Technical Service Bulletin: TSB190052

New Fuel Pump Inlet Filter Screen

- QSK38 CM2150 K106
- QSK38 CM850 MCRS
- QSK50 CM2150 K107
- QSK50 CM850 MCRS
- QSK60 CM2150 MCRS
- QSK60 CM850 MCRS

Figure 1, New Fuel Pump Inlet Filter Screen.

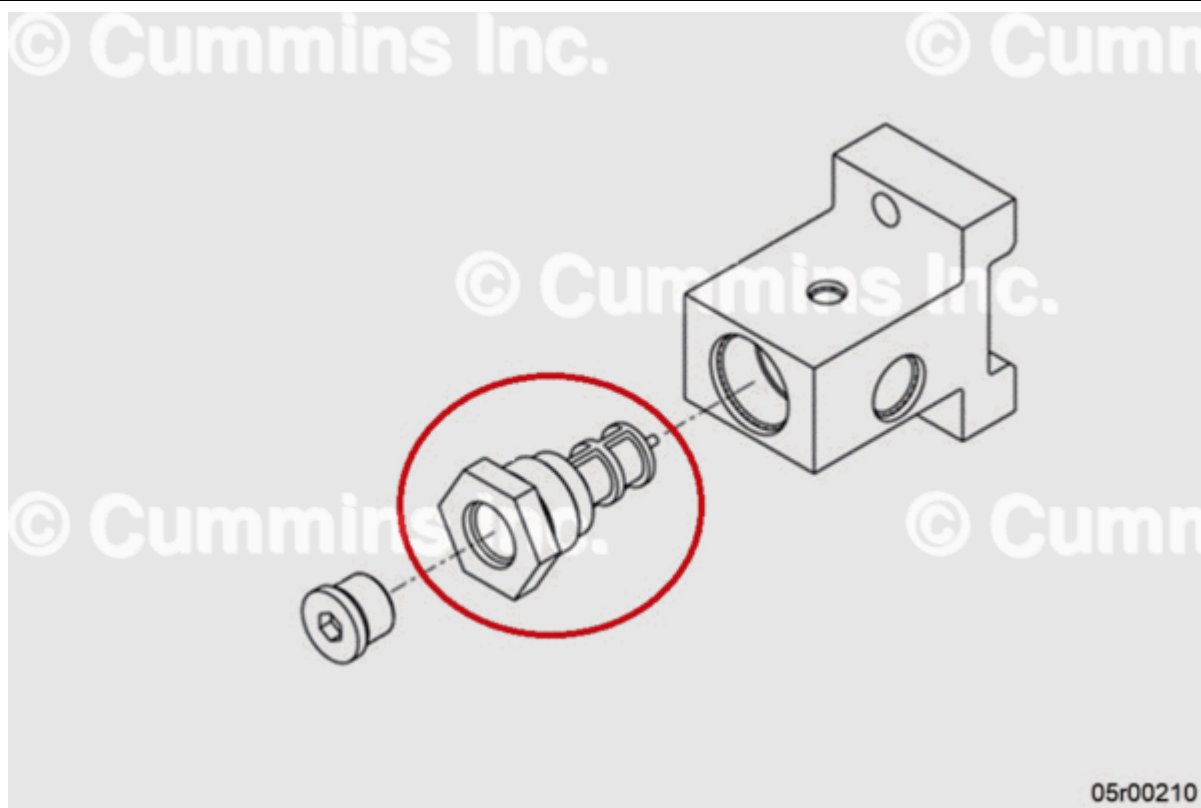
A new fuel pump inlet filter screen has been released to provide additional protection against debris entering the fuel pump.

- New fuel pump inlet filter screen consists of an adapter to be installed into a revised fuel supply manifold.
 - Fuel pump inlet filter screen torque specification is 185 N•m [136 ft-lbs].
- There is no approved cleaning procedure for the fuel pump inlet filter screen and must be replaced when necessary.
- PA threaded protective plug can be ordered if engine was shipped without original equipment manufacturer (OEM) fuel inlet plumbing. See Table 1 below for part number information.
